Docket Number:	15-AAER-02
Project Title:	Pool Pumps and Spa Labeling
TN #:	212742
Document Title:	California Investor Owned Utilities Comments: CA IOUs Title 20 Response to REVISED Draft Regulations_Pool Pump Motors and Portable Electric Spas 8-11-2016
Description:	N/A
Filer:	System
Organization:	California Investor Owned Utilities
Submitter Role:	Public
Submission Date:	8/11/2016 11:57:46 AM
Docketed Date:	8/11/2016

Pool Pump Motors & Portable Electric Spas

Comments regarding revised draft regulations:
Pool pump motors & portable electric spas

Docket # 15-AAER-02

Figure 1: CEC’s Proposed Motor Efficiency Standards for Single Speed Motors
 Source: CEC Revised Staff Report, 2016

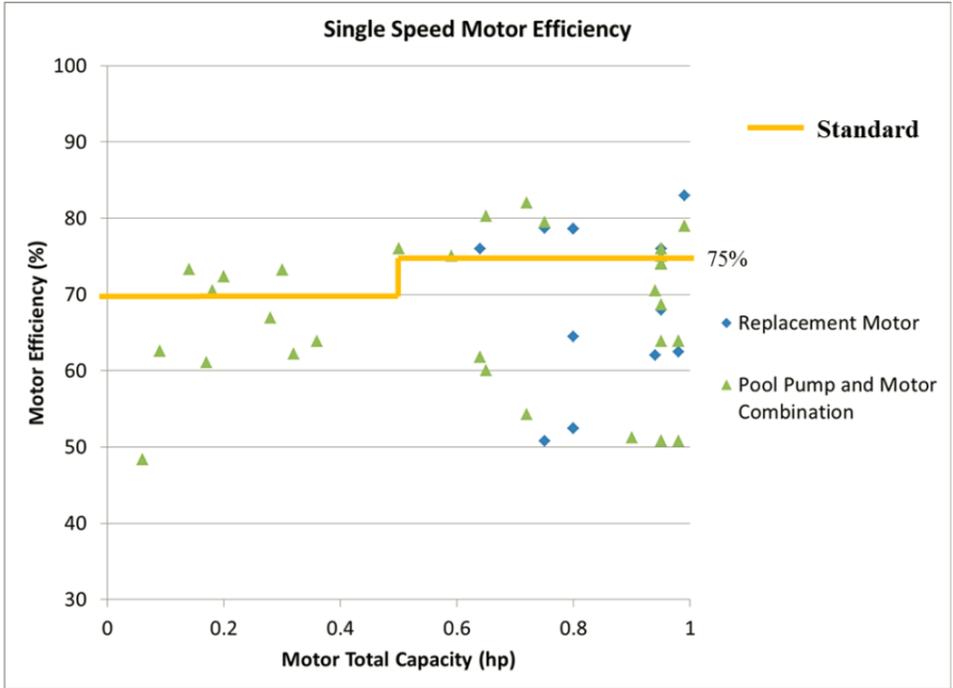
The CA IOUs also support CEC’s proposed motor efficiency standard levels. The previous January 2016 CEC staff report had proposed two tiers for motor efficiency; however, we believe the currently proposed single tier will capture savings sooner and lead to less confusion for the market. We also support CEC in acknowledging diverse stakeholder feedback and working to create a strong proposal that also provides some relief to very small pool pump motors. We believe the January 1, 2019 compliance date is reasonable as there are already numerous products on the market that meet the proposed standards, which can be seen below in Figure 1 from CEC’s revised staff report.

Figure 2: CEC’s Proposed Motor Efficiency Standards for Multiple Speed Motors
 Source: CEC Revised Staff Report, 2016

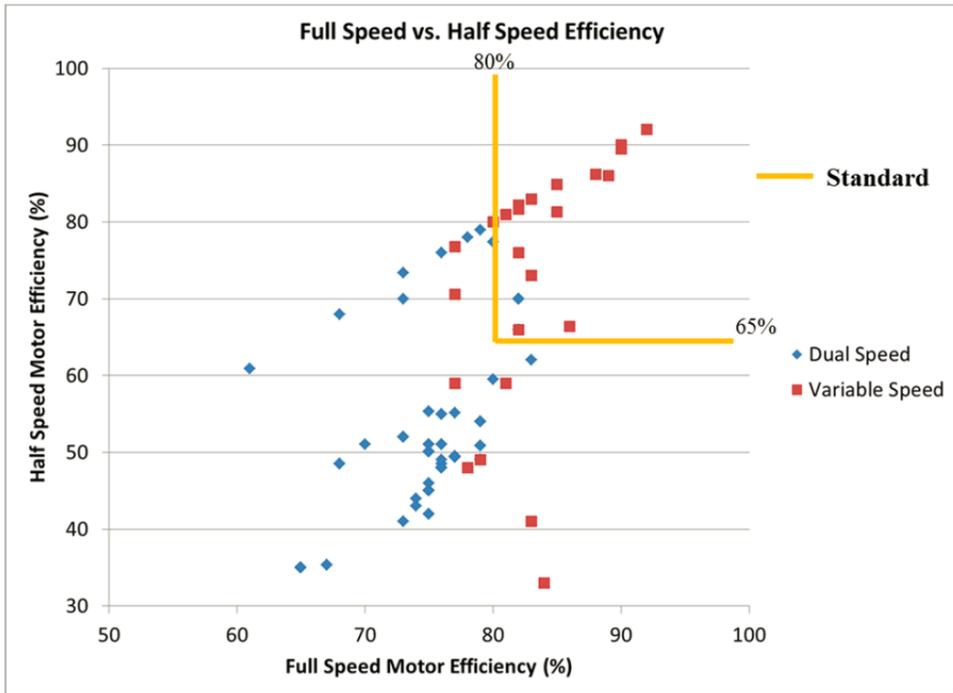
Additionally, there are numerous two-speed and variable speed products that meet the proposed standard, as shown below in Figure 2 from CEC’s revised staff report.

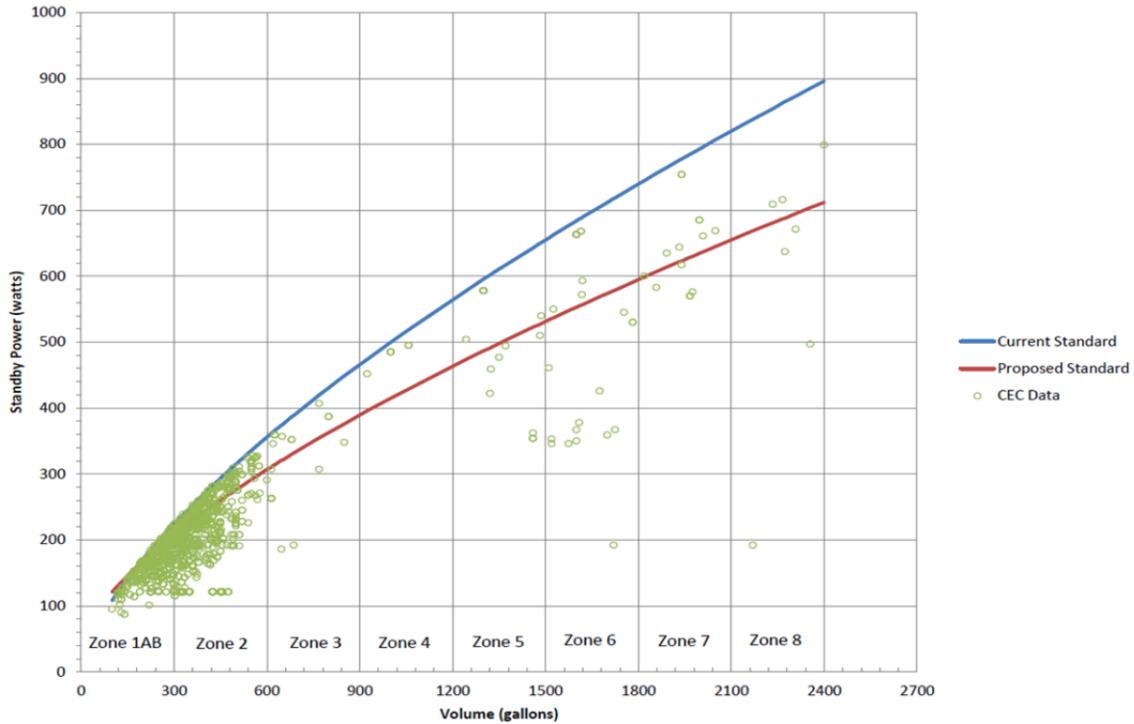
In summary, the CA IOUs support CEC’s proposal to expand the scope of coverage to include combination and exercise spas under the proposed maximum allowable standby power level of $40+3.75*Volume^{(2/3)}$ watts.

Figure 4: CEC's Original and Currently Proposed Label for Portable Electric Spas

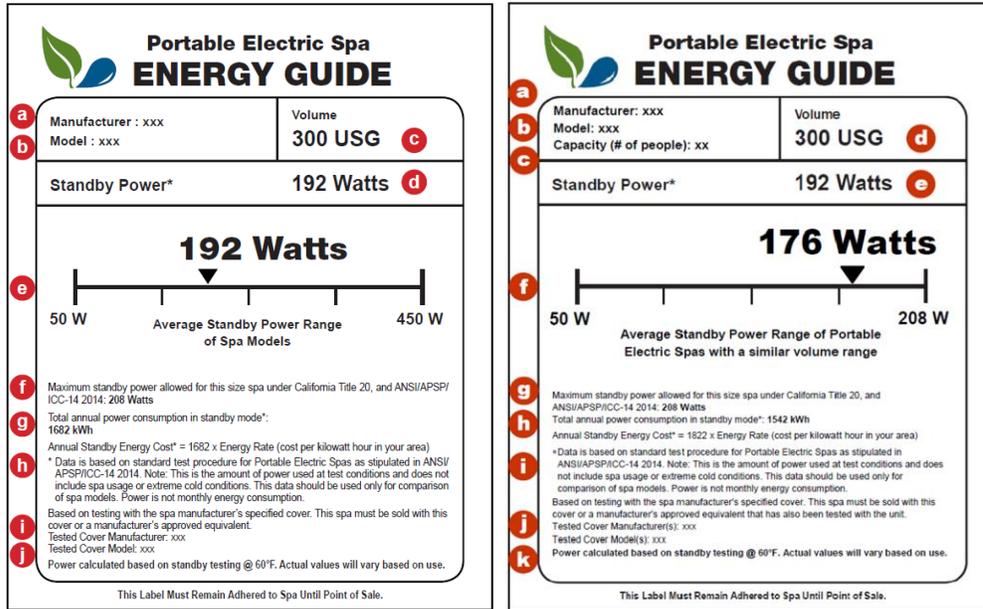
The CA IOUs broadly support the labeling scheme CEC staff has proposed (seen below in Figure 4) which reflects the work between the CA IOUs and the APSP-14 committee in the spring of 2014. This label design was also recommended as part of the CASE report that the CA IOUs submitted to CEC on May 15, 2014, and in the publication of the APSP-14-2014 voluntary standard. This label will provide valuable information to consumers and lead to more energy efficient purchasing decisions. We commend CEC for developing label concepts for exercise and combination spas.

Recommendation: The CA IOUs encourage CEC to use the original proposed design relating to the upper boundary for standby power on the label. In the January 2016 staff report and in APSP-14-2014 the upper boundary for standby power was fixed (See 450 watts in Figure 4). In this revised staff report, CEC proposed to make the upper boundary a function of the maximum allowable standby power (See 208 watts in Figure 4). While we understand CEC's intent to display how a given spa compares to the standard for its given size (gallons), ultimately we prefer the original design that consumers can quickly recognize and compare the relative energy consumptions between spas. CEC's recently proposed design makes all spas look similar with their arrow being pushed far to the right as most spas are clustered closer to their maximum allowable power as compared to 50 watts. Maintaining a fixed upper and lower limit will allow customers to more easily visualize the relative energy consumption of spas when viewing many spas on a showroom floor. It may also lead customers to consider smaller spas as they inherently use less energy.

Recommendation: The CA IOUs propose that combination spas be tested and labeled per APSP-14-2014 as one unit. CEC's revised staff report proposes to test the exercise spa and the portable electric spa separately and list their respective energy performance values separately on the same label. However, we encourage CEC to follow the APSP-14-2014 test procedure that provides direction for testing the combination spas as one unit with the exercise portion heated to 85°F and the spa portion to 100°F. If the two are tested separately, their performance values could be skewed as they share a common structural wall where heat could transfer through from one body of hot water to the other. In summary, we encourage CEC to adopt the test procedure language in APSP-14-2014 and to require a single label for combination spas.

Recommendation: The CA IOUs propose the language on the bottom of the proposed label be changed to indicate that the label must remain on the portable electric spa until "time" of sale to the consumer as compared to the "point" of sale. The "point" of sale could be misconstrued to mean the location of sale, such a spa dealership. To avoid this potential confusion, we encourage CEC to change the language as follows: "This Label Must Be Adhered to Spa Until ~~Point~~ Time of Sale to Consumer".
